# Is Empshott Grange a *safe* school location?

*An evidence-based review of traffic, carriageway geometry and network resilience on the B3006, Mill Lane and Church Lane.*

Proposed school development at Empshott Grange

This document sets out evidence on road safety and the effect of traffic on the community in connection with the proposed school development at Empshott Grange. It relates to planning applications SDNP/24/03736/FUL and the subsequent SDNP/25/03084/FUL. Our central concern is the safety of the lanes that would have to serve the site — roads which are not suitable for the volume and pattern of traffic a school would generate.

## MILL LANE · INSUFFICIENT CARRIAGEWAY WIDTH

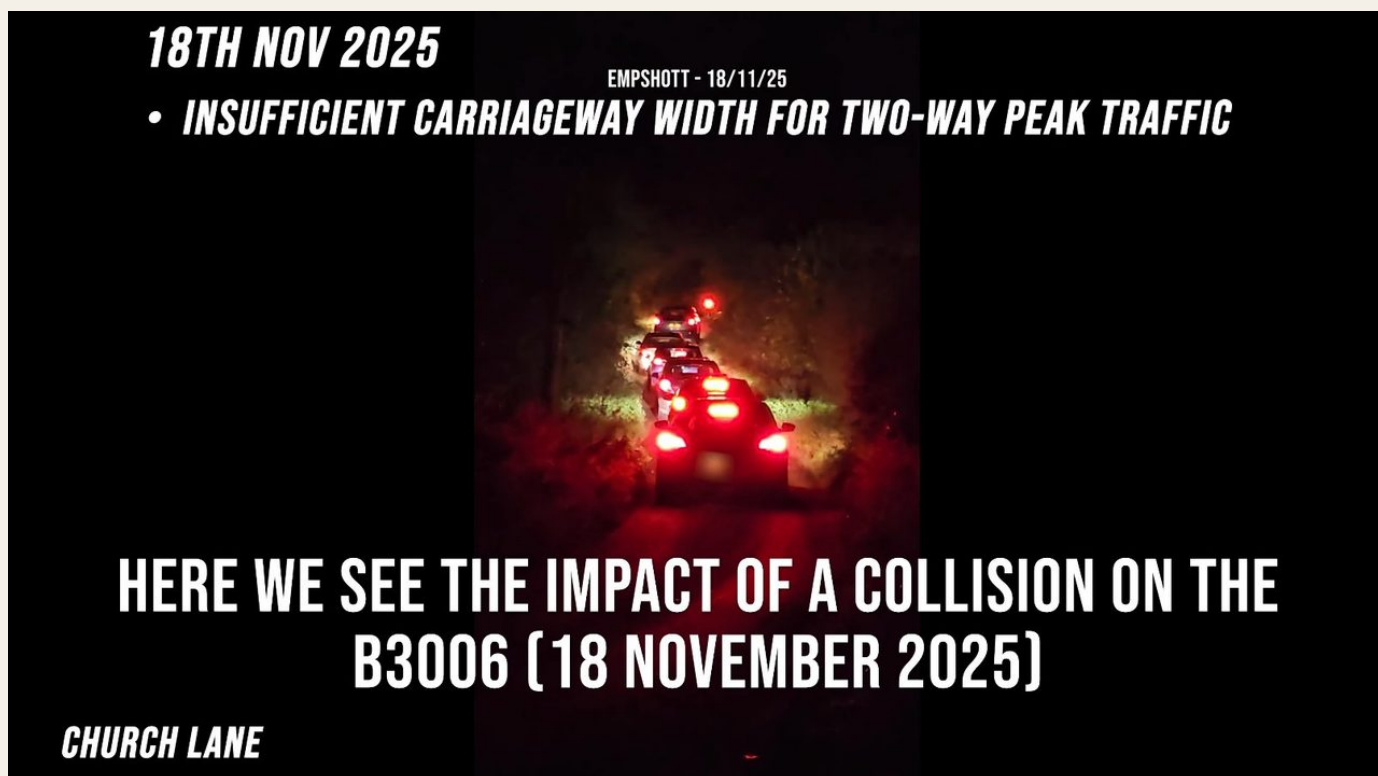
The access route cannot carry two-way traffic

Mill Lane — the principal access route to the site — does not support two-lane traffic. A single-track lane, it has insufficient width for two vehicles to pass; where vehicles meet, one must yield to the verge or reverse to a wider point. The footage shows that even minor increases in traffic cause immediate congestion, and that multiple vehicles arriving simultaneously cause obstruction. Concentrated school-hour movements would force this repeatedly, at the busiest times of day.

A further vehicle leaves the carriageway at the same point

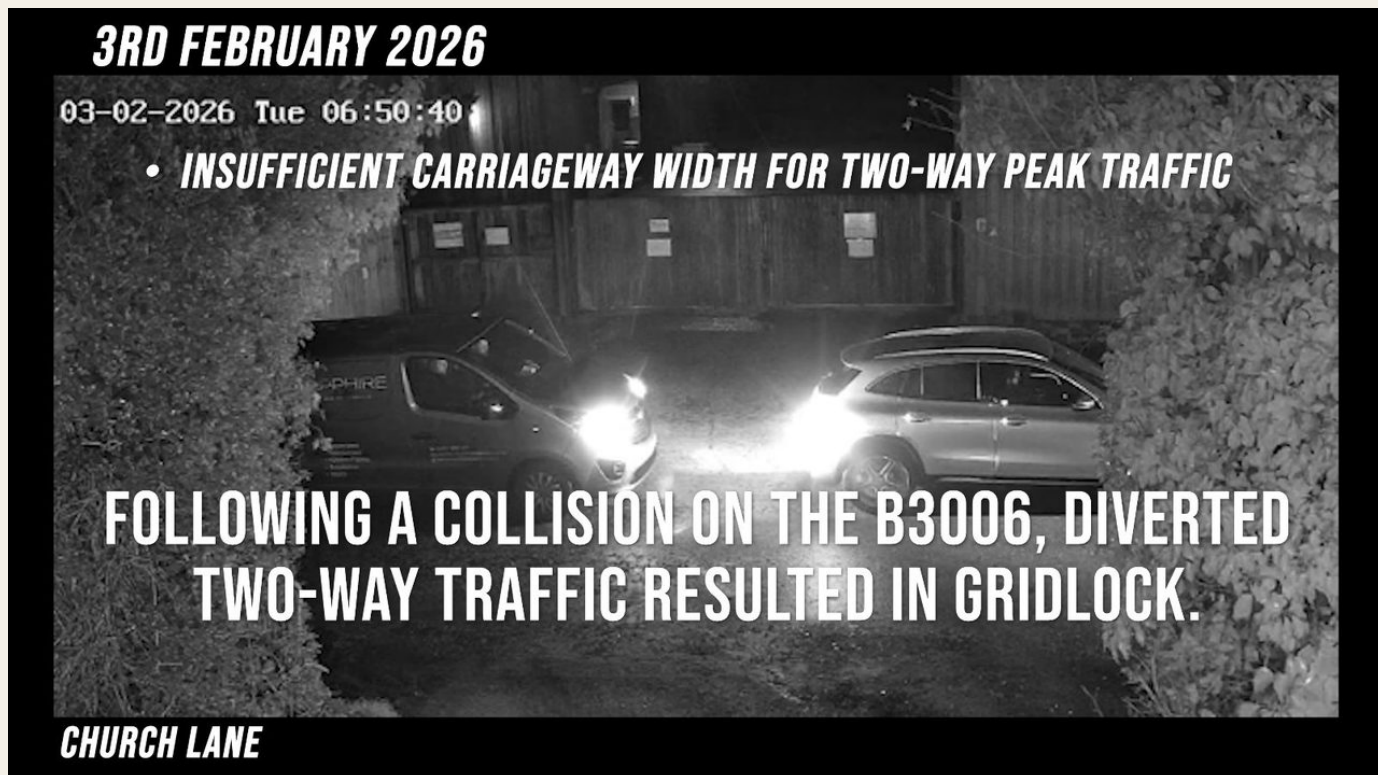
On 24 February 2026 another vehicle left the carriageway at the same constrained point on Mill Lane, again requiring recovery (the recovery vehicle is visible behind). A spot where ordinary vehicles repeatedly run off the carriageway is a measure of how little room these single-track lanes leave, even under today's traffic.

## Very few vehicles before queues reach the B3006

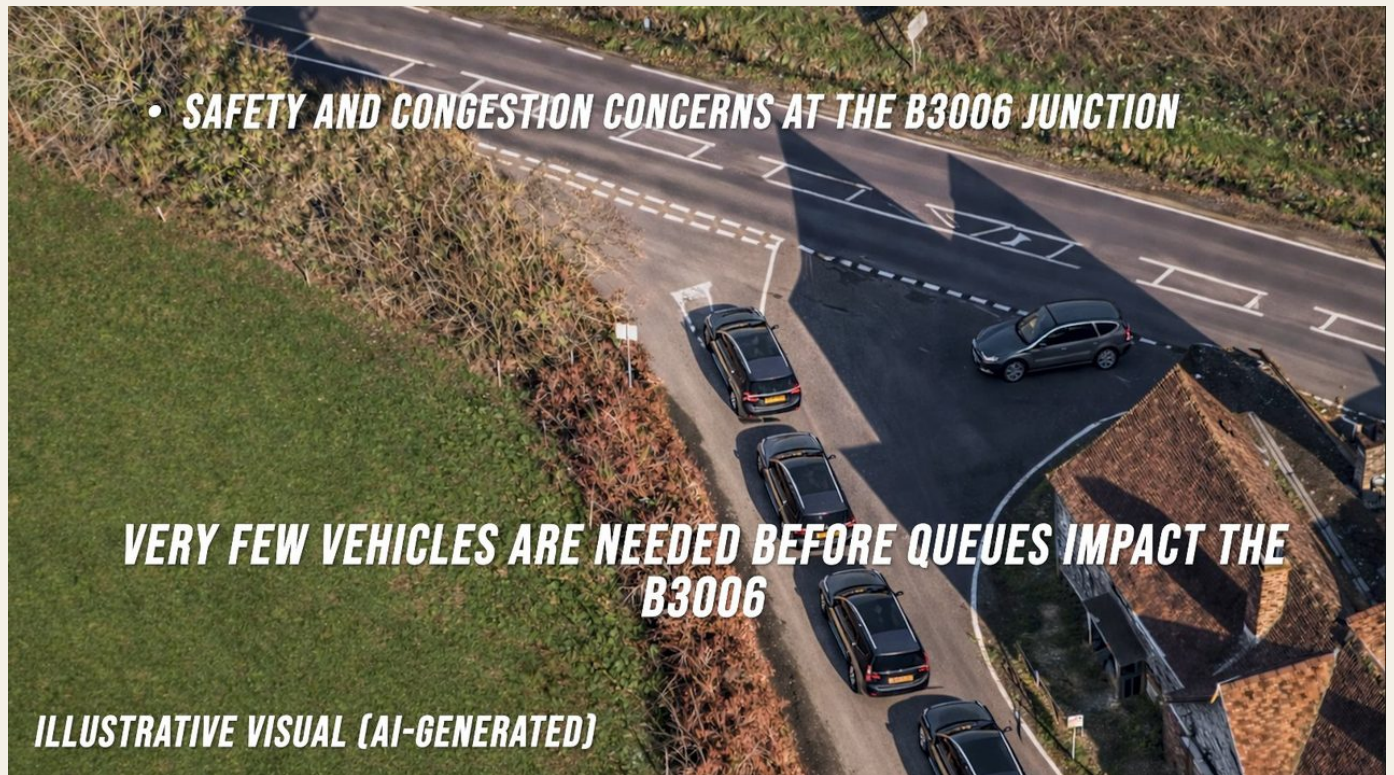
This image is an AI-generated illustration, not documentary footage. It is included only to show schematically how a short queue would reach the main road — the underlying point is evidenced by the real footage above.

It would take only a few vehicles trying to turn out of Mill Lane onto the B3006, and two trying to turn in, for the junction to lock up — pushing the queue back out onto the B3006 and blocking the main road. With school drop-off and collection concentrated into short peaks, that could happen daily.

# Three vehicles bring Church Lane to a standstill

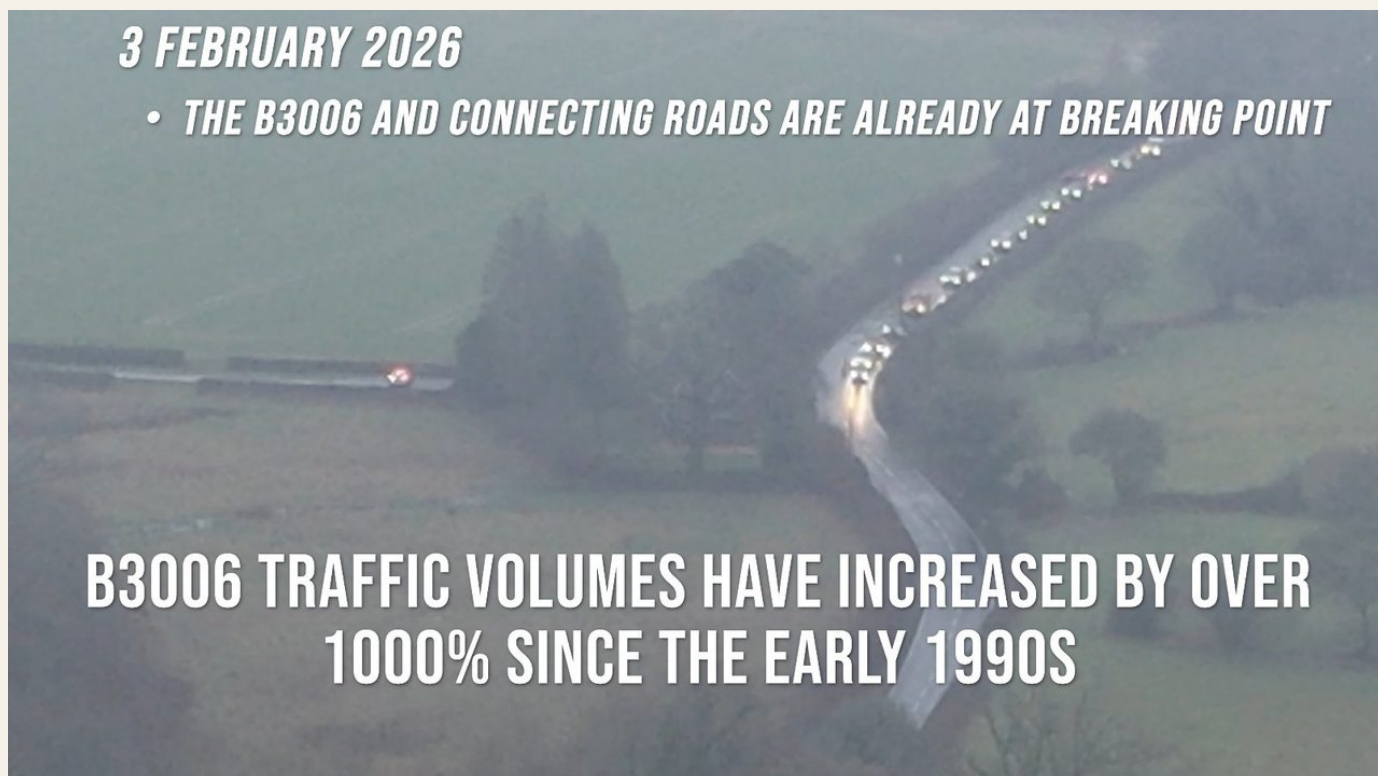
Church Lane is narrower still. Although its use is discouraged, nothing physically prevents drivers from taking it — and satnavs routinely direct traffic down this route. It takes only three vehicles meeting to bring the lane to a complete standstill, with reversing the only way out.

School traffic seeking to avoid delays at the main Mill Lane/B3006 junction would inevitably find its way onto Church Lane, increasing the risk of blockages on a lane that is already unsuitable for two-way traffic.

## A road already carrying far more than it was built for

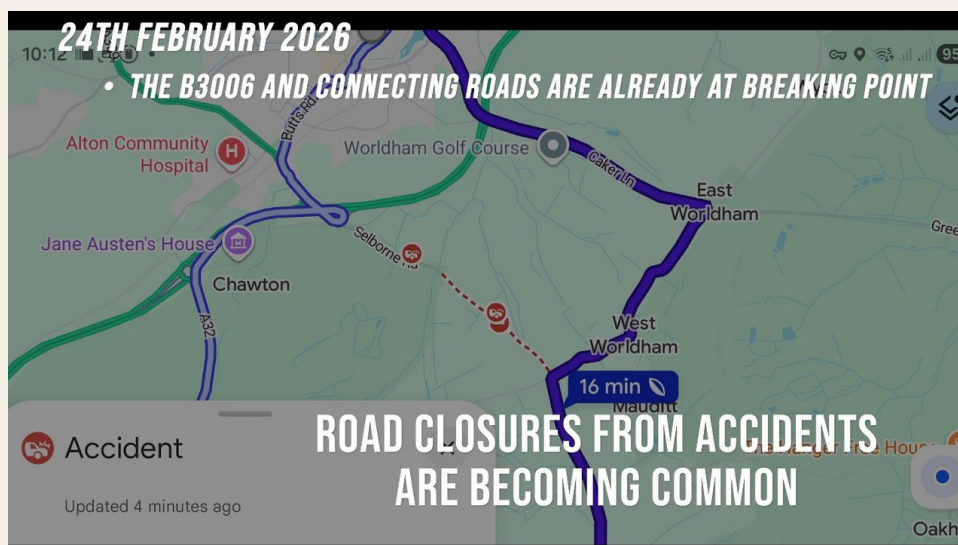
The B3006 is a rural B-road now carrying heavy commuter flows. Traffic has risen by more than 1,000% since the early 1990s, taking it far beyond the level it was designed to accommodate.

With significant housing growth being promoted across East Hampshire and the wider A31 corridor, and with no planned bypass or meaningful alternative route, these pressures are likely to worsen over time. Queues, delays, accidents and road blockages will place increasing strain on both the B3006 and the surrounding village lanes that are forced to absorb its traffic when it fails.

## Incidents push diverted traffic through the village

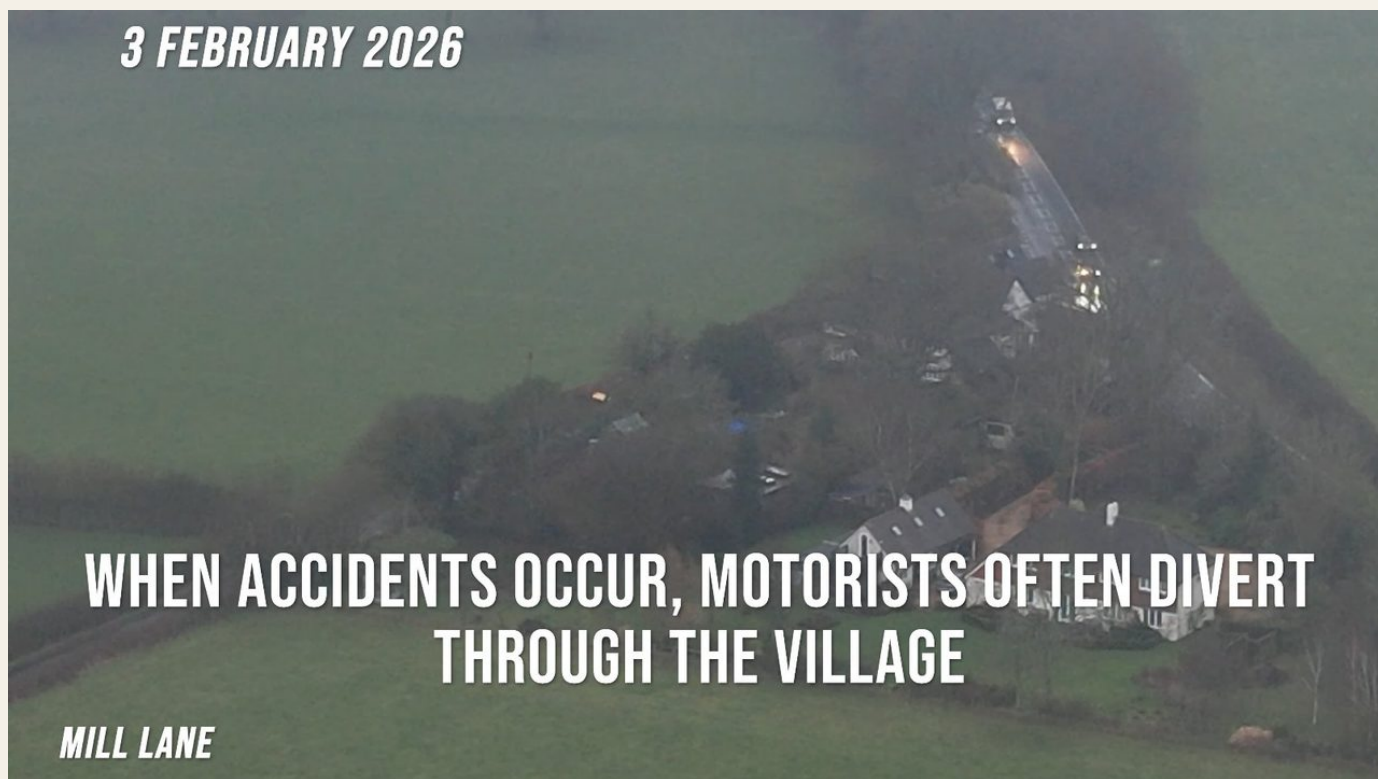
When accidents occur on the B3006, motorists often divert through the village along Mill Lane and the connecting lanes — routes with no pavements, shared with residents, walkers, horse riders and cyclists. Past incidents already show how quickly that extra traffic overwhelms the village network. The concern is that a school would make the exceptional routine: more traffic, and the incidents that come with it, would mean more frequent diversions — until the congestion seen today only during an incident becomes a daily, peak-time condition, with vulnerable road users exposed each time.
